TSB140117

Fault Codes 555 and 556 Caused by Dust and Debris Ingestion on Ford® F-650 and F-750 Chassis

Figure 3: Buildup of dirt and debris on turbocharger compressor inlet.

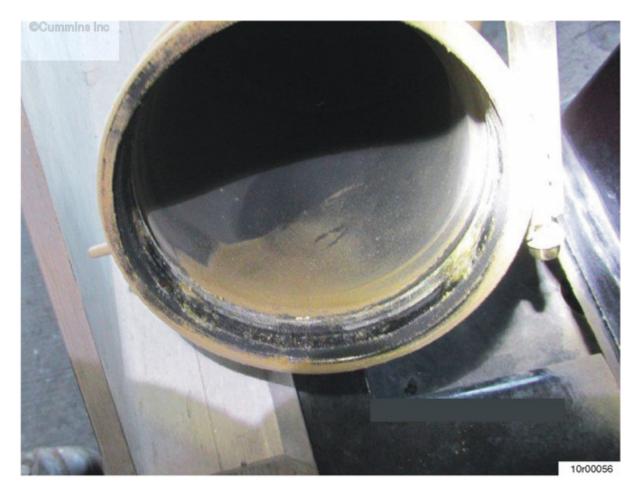
If clamp has already been removed, see Figures 3 and 4 that show dust and debris buildup where clamp seals at turbocharger compressor inlet.

When installing air intake tube between air filter housing and turbocharger compressor inlet, tighten both clamps to specified torque value.

9 N·m [80 in-lb]
